WATER SUPPLY SUBMISSIONS REPORT

State Significant Development No. 5765

October 2022

Bowdens Silver Project Water Supply Submissions Report

Figure 5.3b Average Annual Main Water Source Inflows - Revised

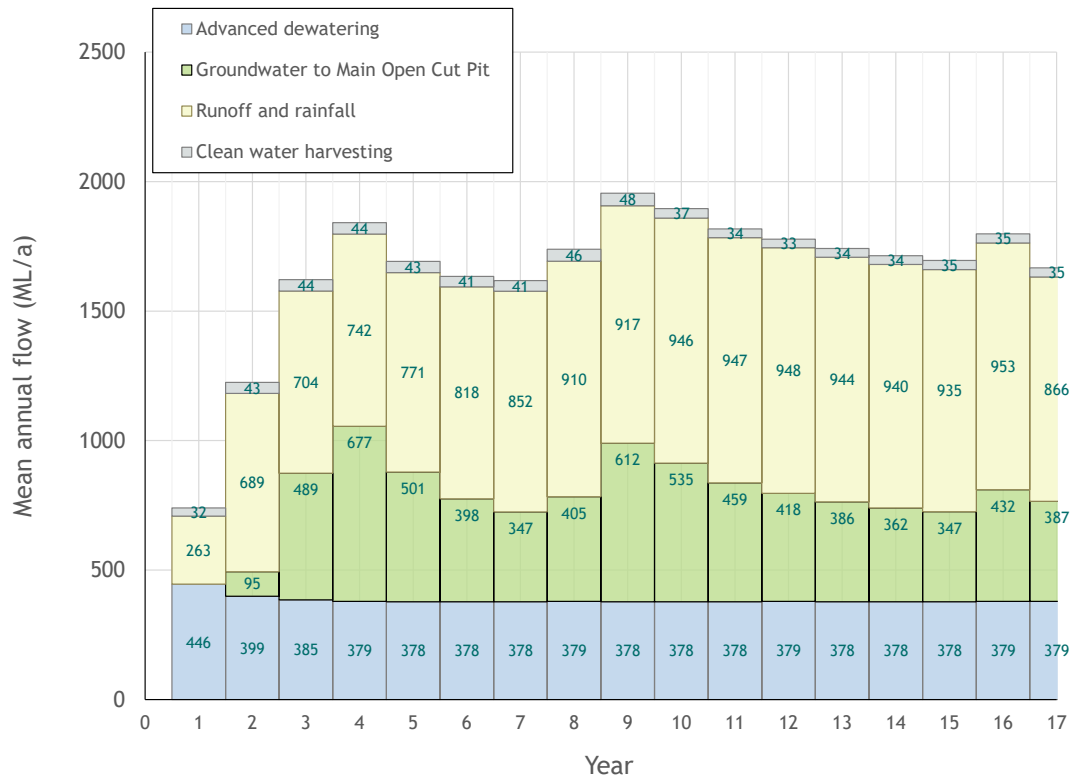
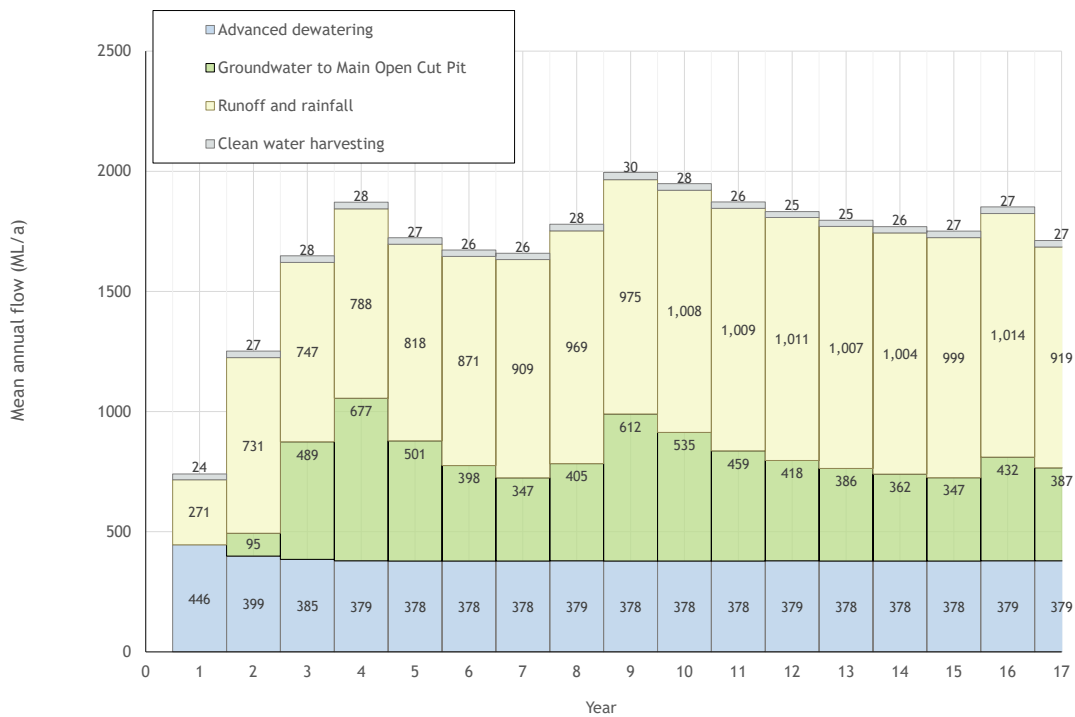
The outcomes of the updated modelling are presented in a brief memo prepared by WRM titled *Impact of May 2022 amendment to Harvestable Rights Order on water supply reliability* is included as **Appendix 2**. In summary, the harvestable rights storage dams provide an important but not critical part in the integrated water management and supply strategy. The new rules applied through the Harvestable Rights Orders limit the transfer of water but do not prohibit the use of the harvestable rights dams. Therefore, the water captured in these dams is reduced but not removed.

The average annual water balance shows that the change reduces the volume of clean water runoff that can be harvested. However, as this represents only a small component of total water supply, the change does not substantially increase water supply risks.
